# CITY OF ALBUQUERQUE

RE: **Array Technologies Paving  
3901 Midway PL NE  
Grading and Drainage Plan  
Engineers Stamp Date 4/22/2015 (E17D034C)**

RE: **Array Technologies Paving**  
**3901 Midway PL NE**  
**Grading and Drainage Plan**  
**Engineers Stamp Date 2/23/2015 (E17D034C)**

RE: **Array Tech Addition – 3901 Midway Place NE**  
**Drainage Report and Plan for Building Permit**

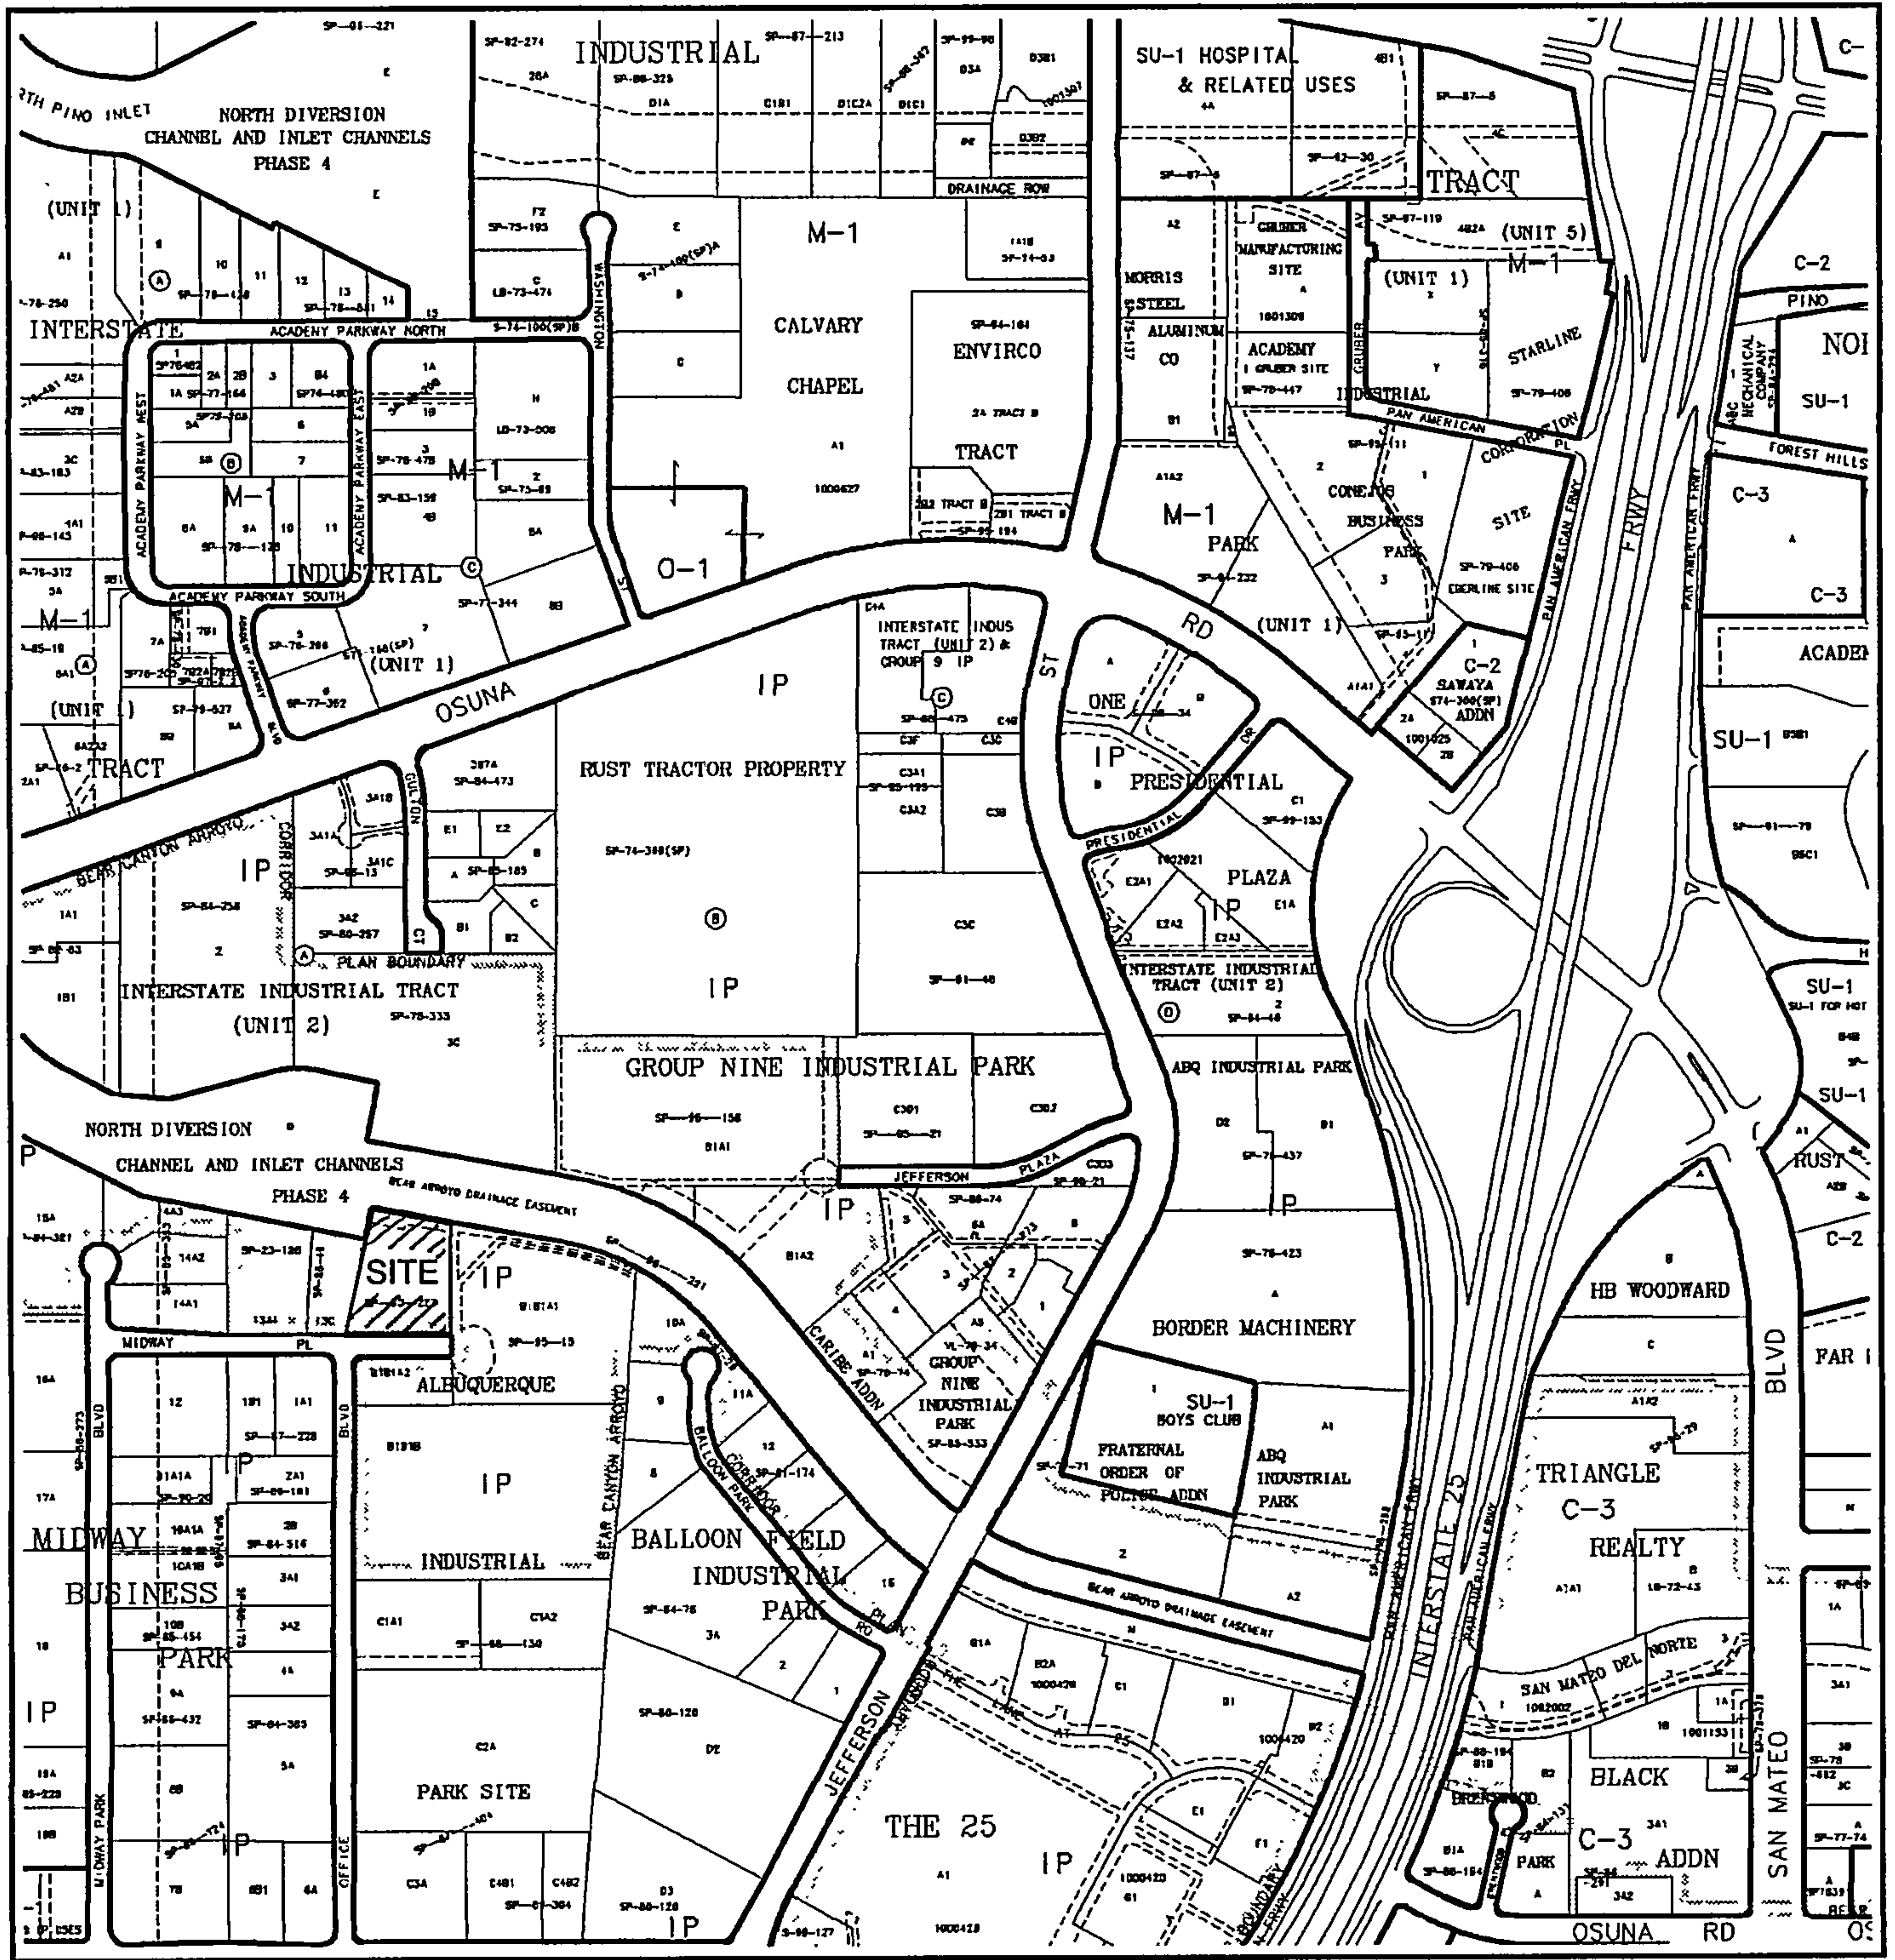
- Mention of the first flush per EPA standards is required and placed on the plans. The amount required for detention is .34" times the new impervious area. Depress the landscape islands/areas as part of the first flush requirements.

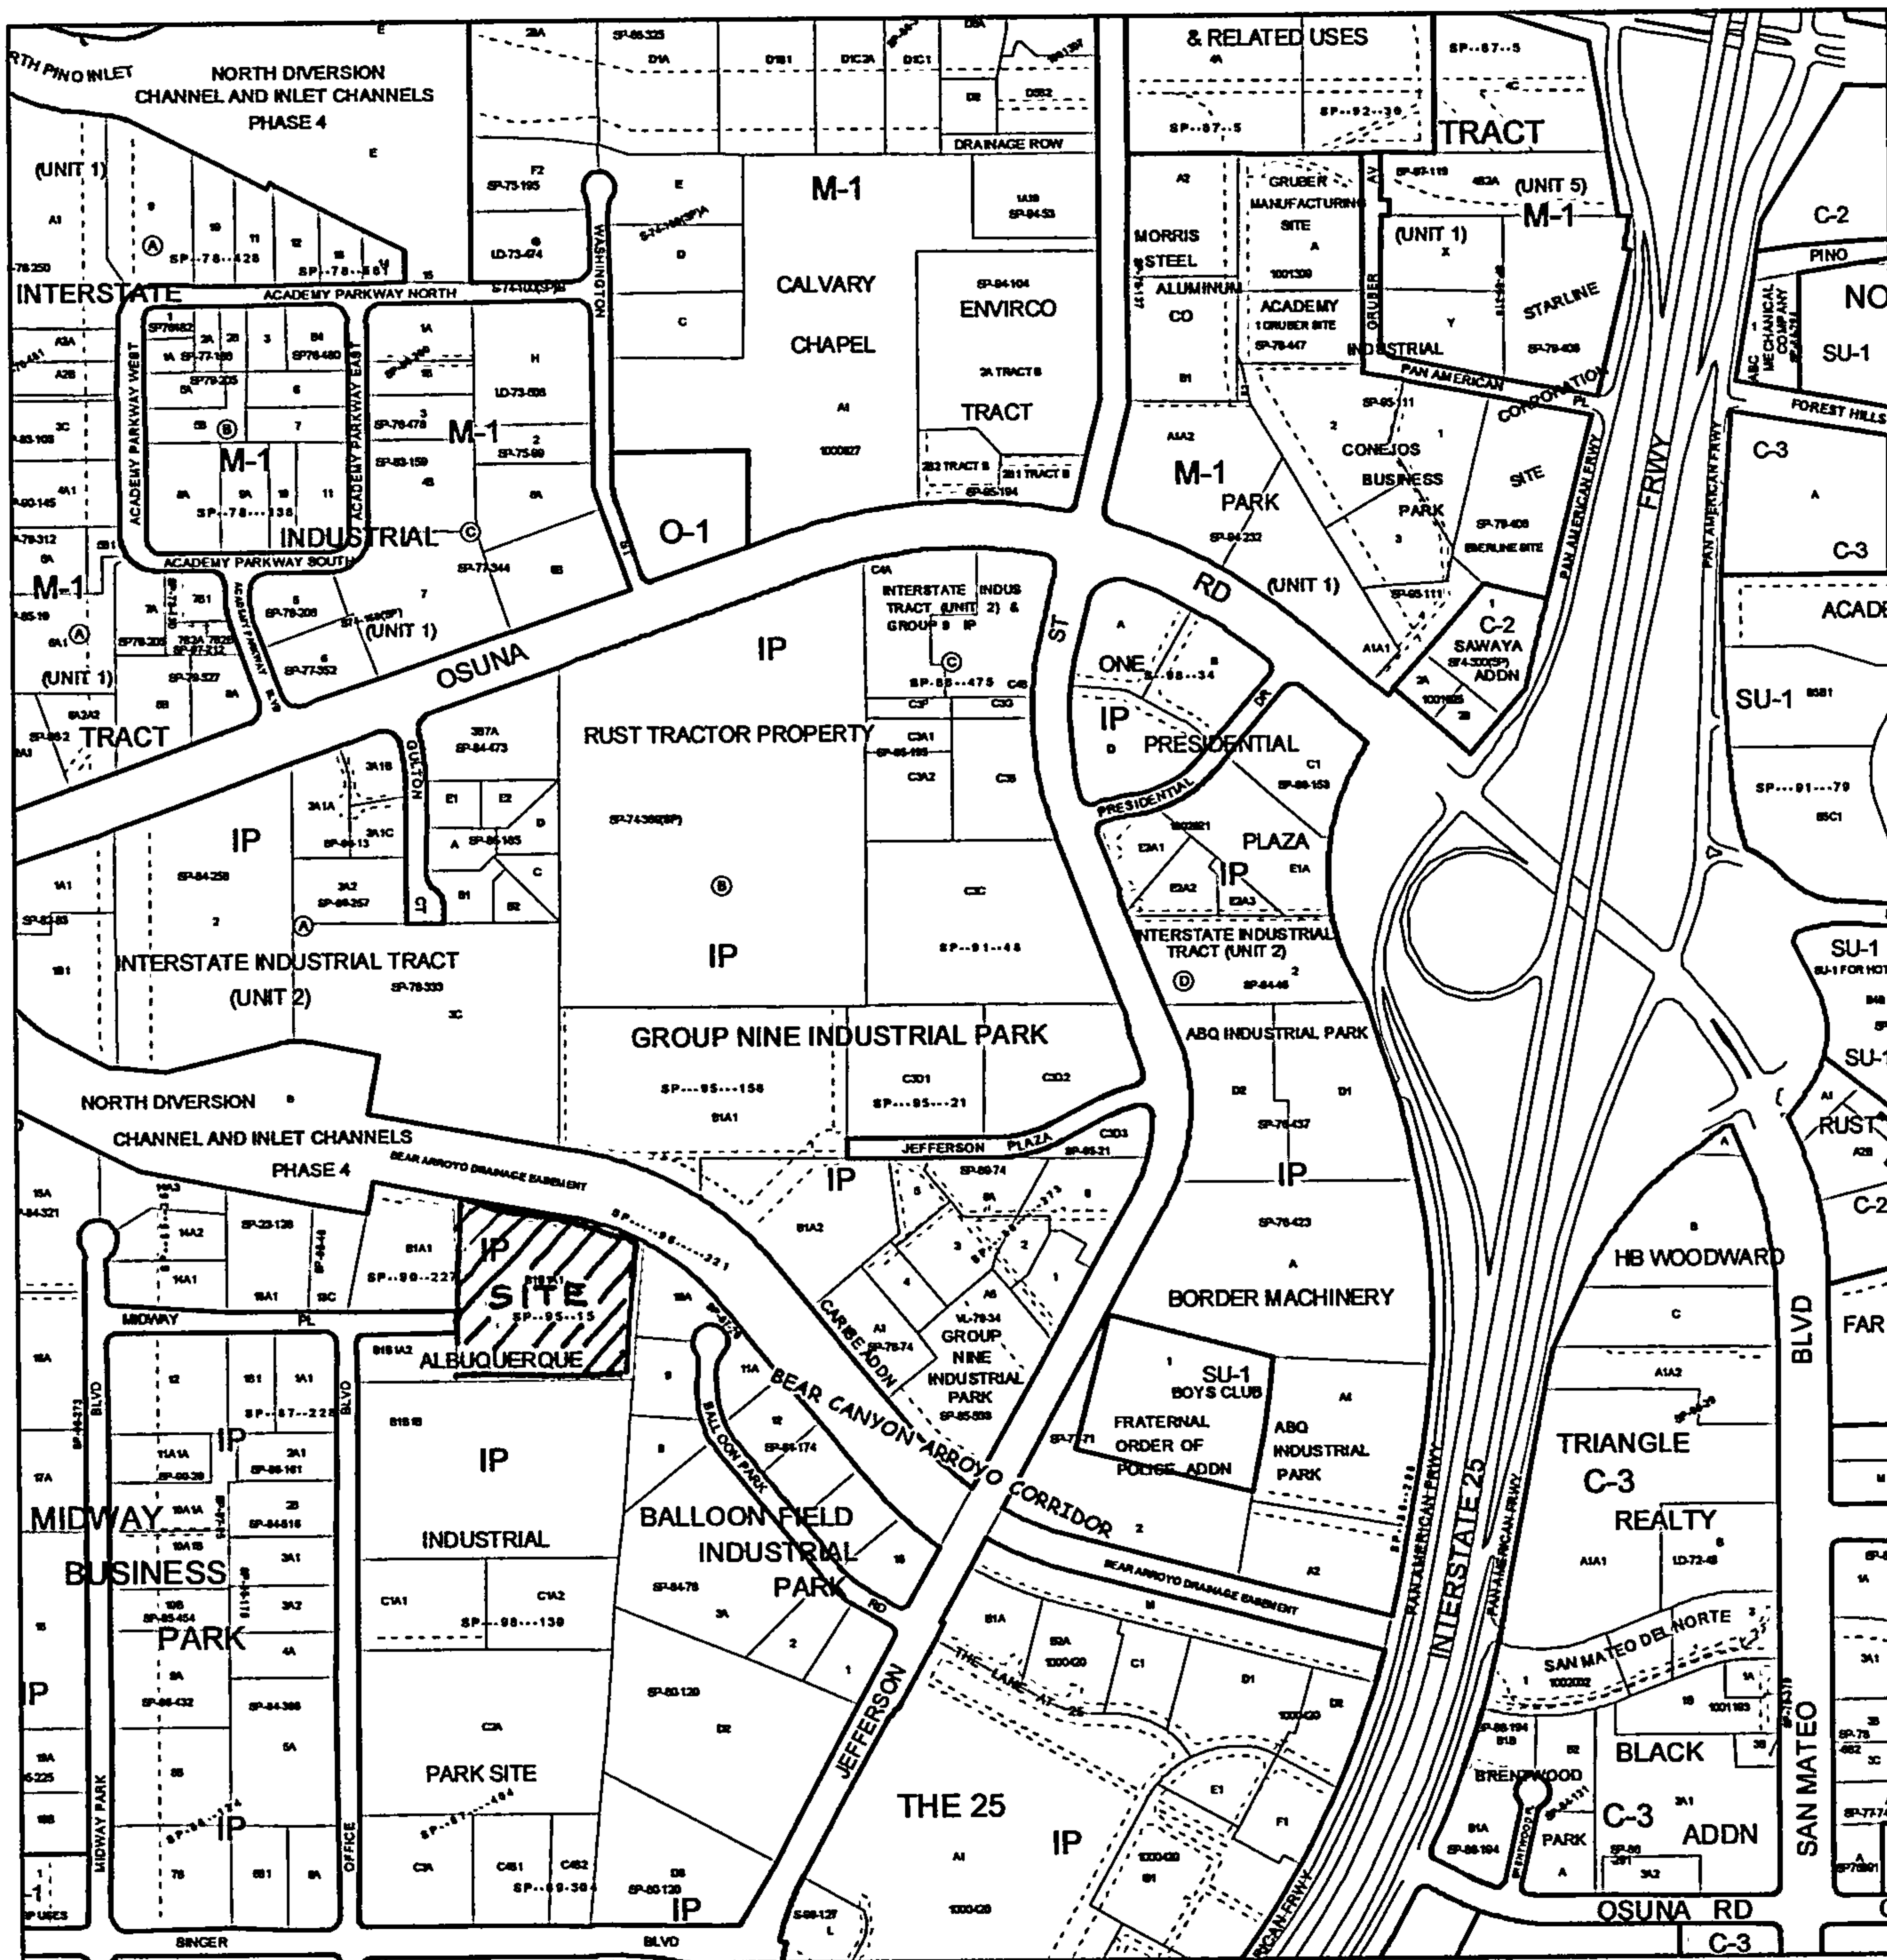
Proposed adds 1/2 Ac.  
of bldg & calcs a  
reduction in flow  
Verify!
